Subject: Minutes of the February 15, 2008 MAGNASTOR Draft RAI Teleconference
Docket No. 72-1031 (TAC No. L23764)

Draft RAI Teleconference
Docket No. 72-1031, (TAC No. L23764)
March 7, 2008

MAGNASTOR Draft RAIs
NRC Conference Call February 15, 2008

Figure 3.8.3-1 Overall Model Plot for a Typical PWR Fuel Assembly

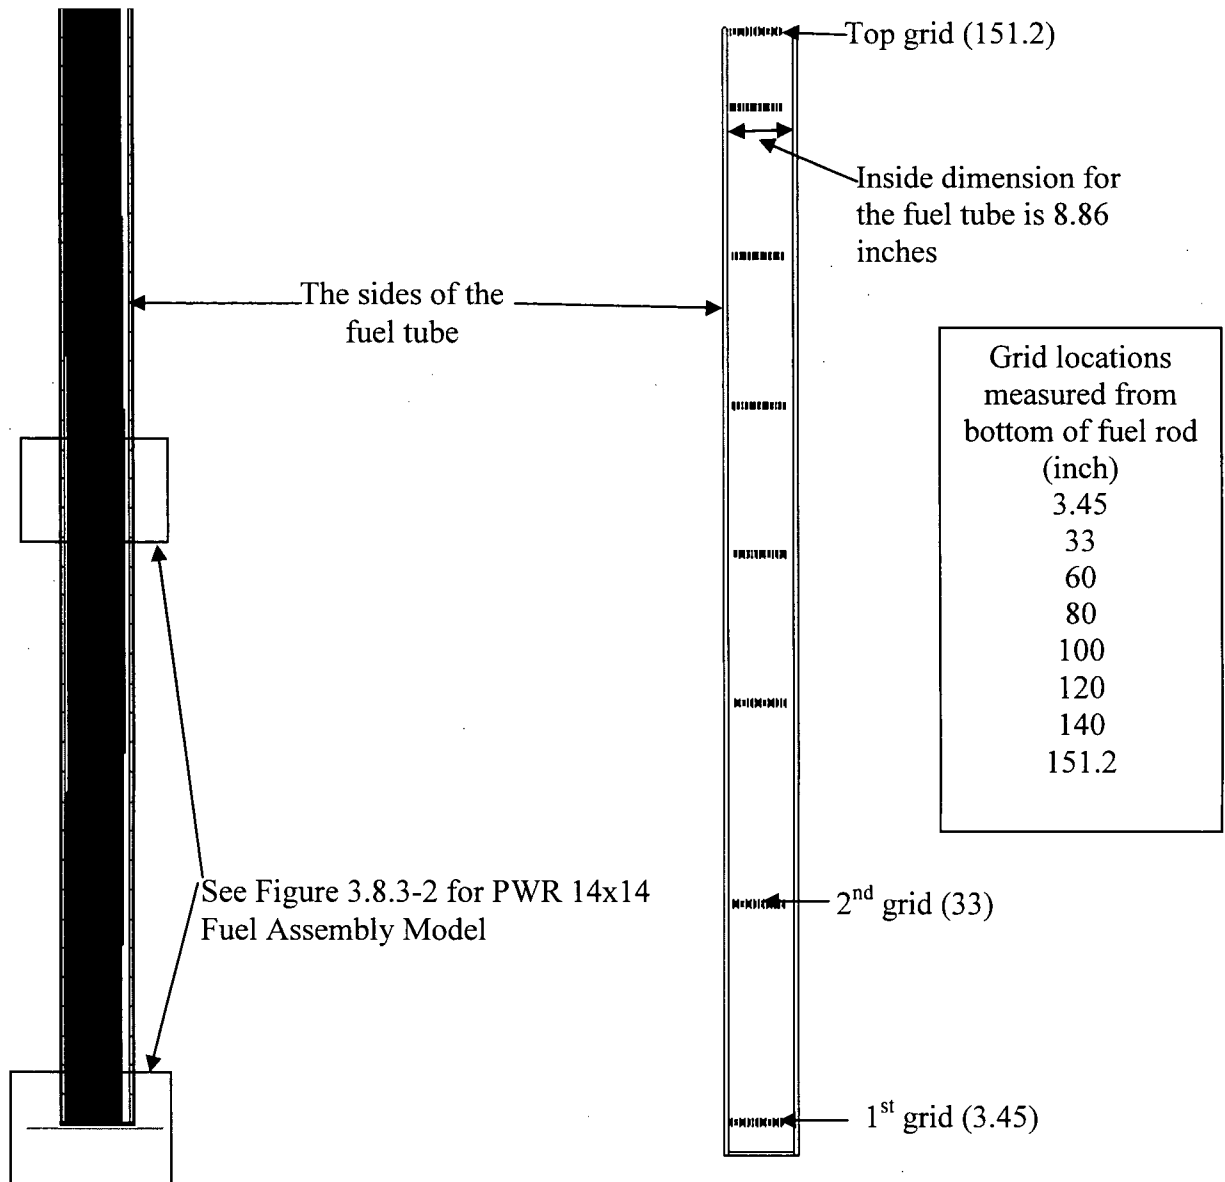
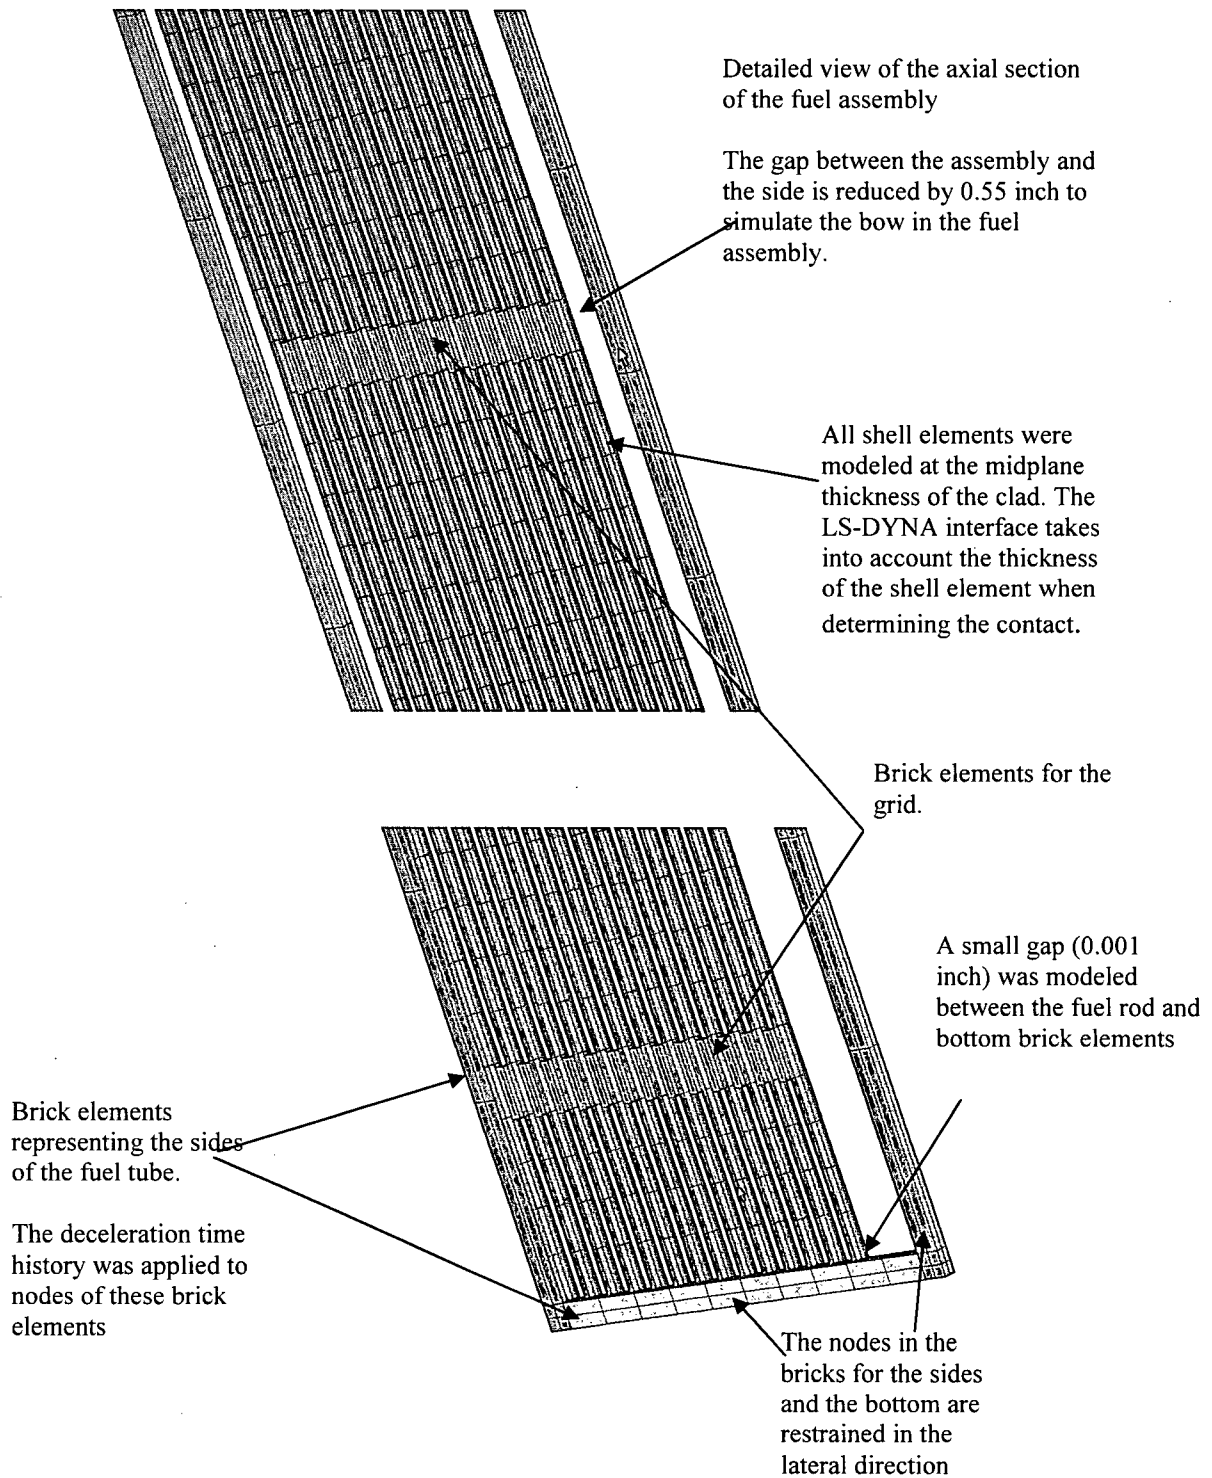
Revise Section 3.8 of the SAR fuel rod structural analysis for the 24-inch handling height concrete cask vertical drop accident. Add a fuel rod structural integrity evaluation for the side-drop impact associated with the concrete cask tip-over accident.

Section 3.8.1 will be replaced by the following presentation:

The description of the side drop for the fuel assembly will be included in a new Section 3.8.4, as follows.

Figure 1-A-1 BWR Partial Length Fuel Rod Location Sketches

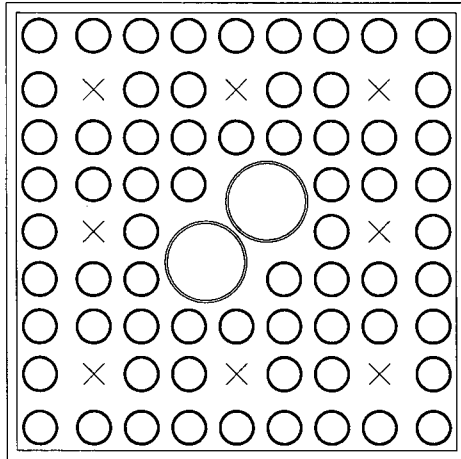
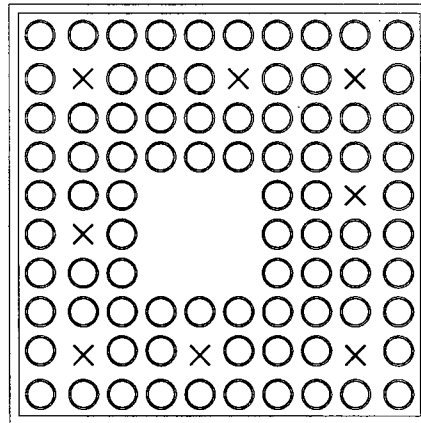
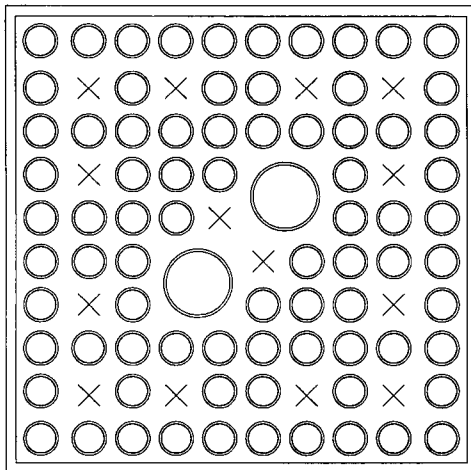
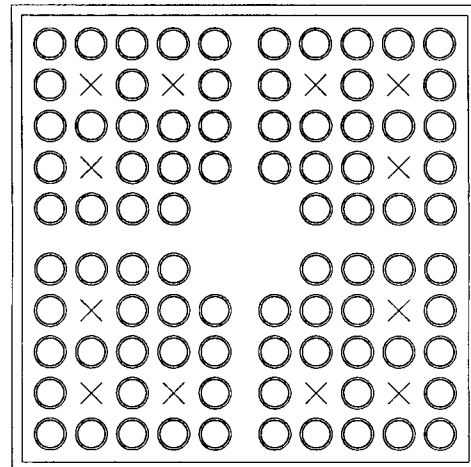
Change footnote a of Table 2-10 in Appendix B of the proposed Technical Specifications to read: Location of the partial length rods is illustrated in Figure 6.2.1-1 of the FSAR (Rev. 1, July 2007).

The current footnote reference does not match the actual figure depicting the locations of the partial-length rods for the applicable assemblies. Furthermore, the reference needs to indicate the appropriate revision of the drawing upon which the criticality analysis and the allowable contents specifications are based. This is necessary because any changes to the applicable assemblies with respect to the positioning of the partial-length rods constitute a change in the allowable contents specifications. This information is needed to confirm compliance with 72.236(a).

“Location of the partial length rods is illustrated in ***Figure 1-A-1*** of the FSAR.”

Table 1-A-2 covers the types of assemblies and their characteristics for the BWR 87-assembly and 82-assembly fuel baskets. ***Figure 1-A-1 locates the partial length rods within the BWR lattice.***
